**PLANNING BOARD
PORTSMOUTH, NEW HAMPSHIRE**

August 17, 2023

AGENDA

To: Planning Board
From: Peter Stith, Planning Manager
Date: August 17, 2023
Re: Recommendations for the August 17, 2023 Planning Board Meeting

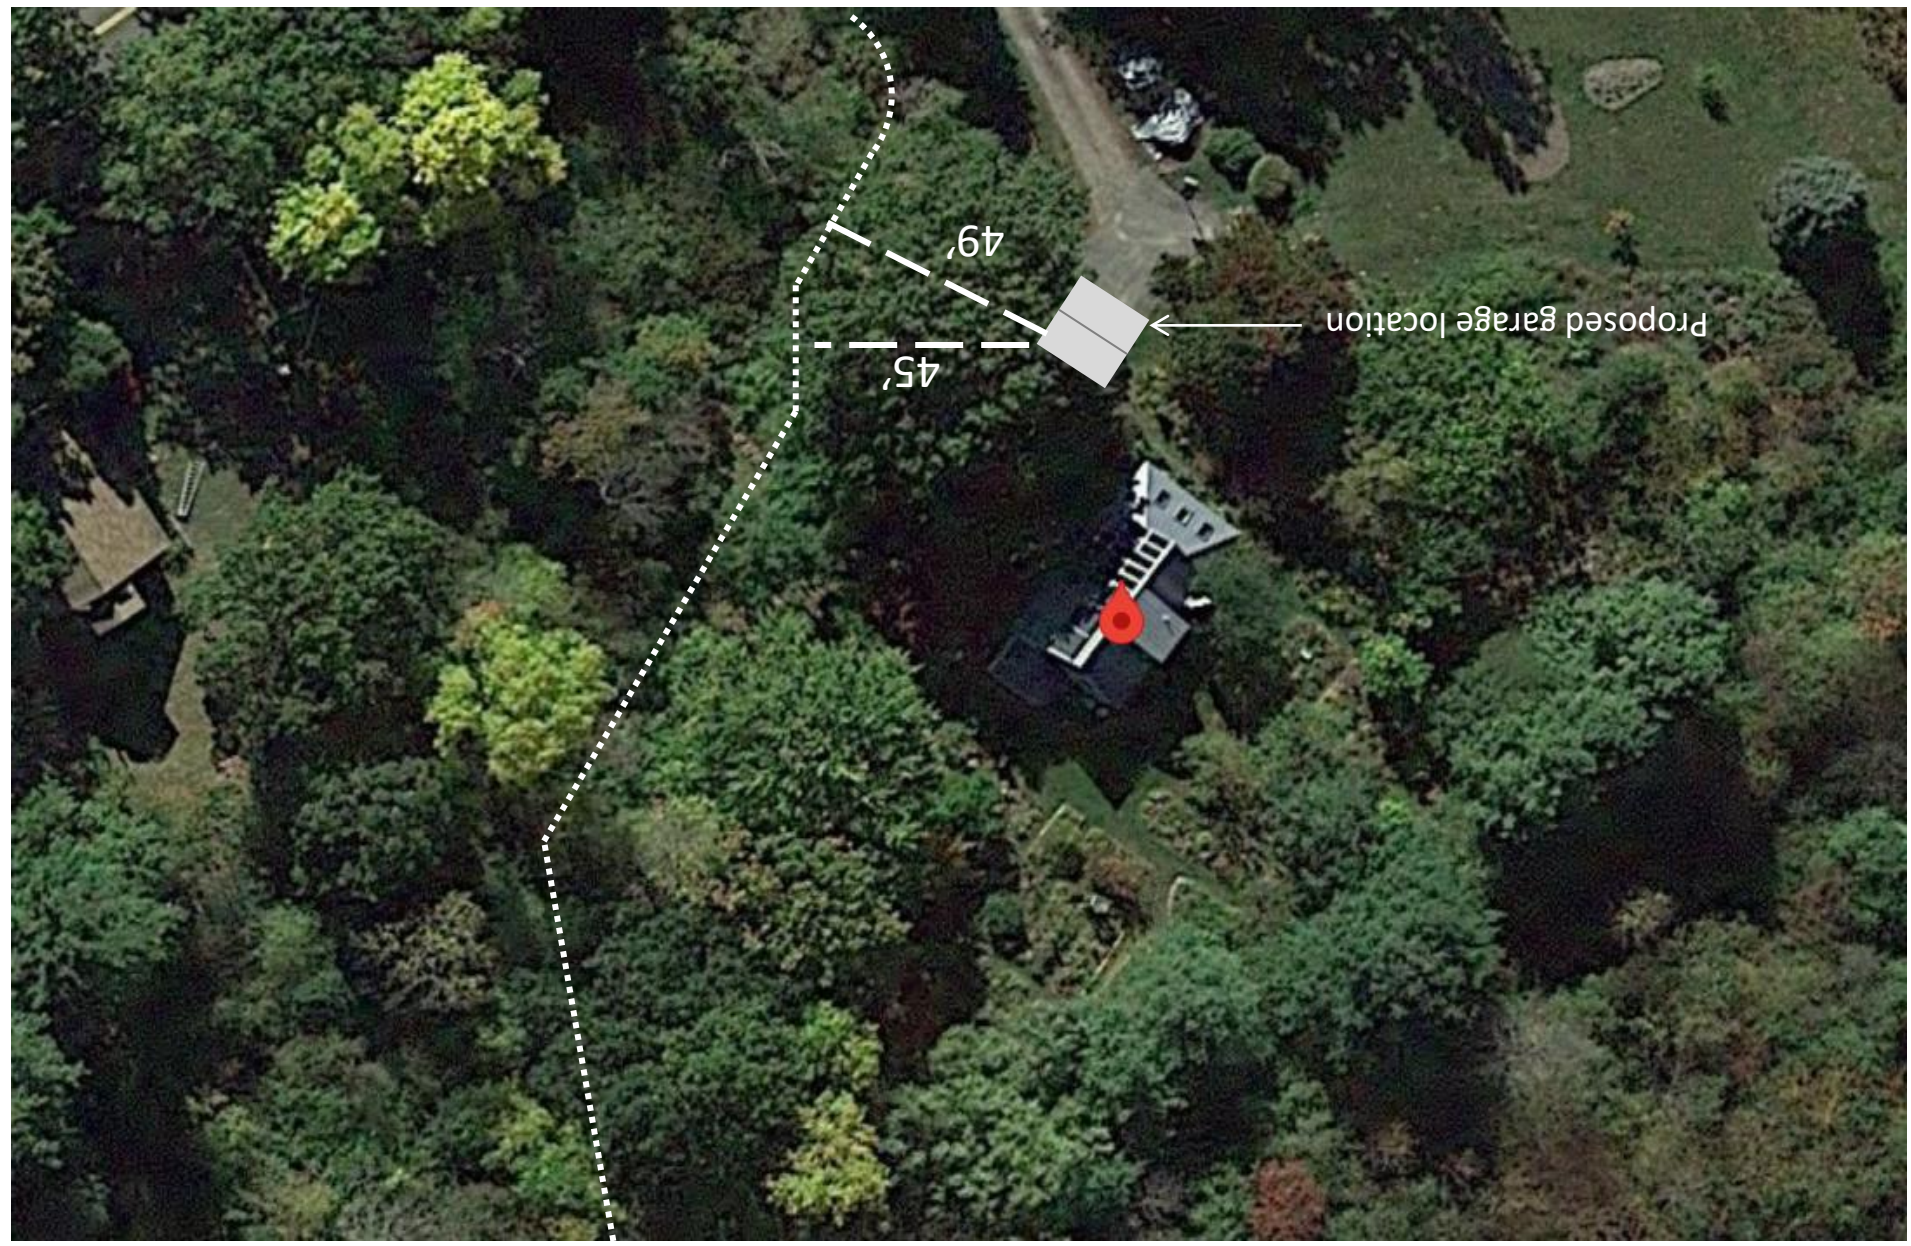
- 1. The applicant shall provide detailed specifications for the proposed pervious pavers including a cross-section plan and information about how they will be installed within the driveway area.*
- 2. The applicant shall provide a maintenance plan for the proposed pervious pavers.*

- 2.1) The applicant shall provide detailed specifications for the proposed pervious pavers including a cross-section plan and information about how they will be installed within the driveway area.*
 - 2.2) The applicant shall provide a maintenance plan for the proposed pervious pavers.*
-
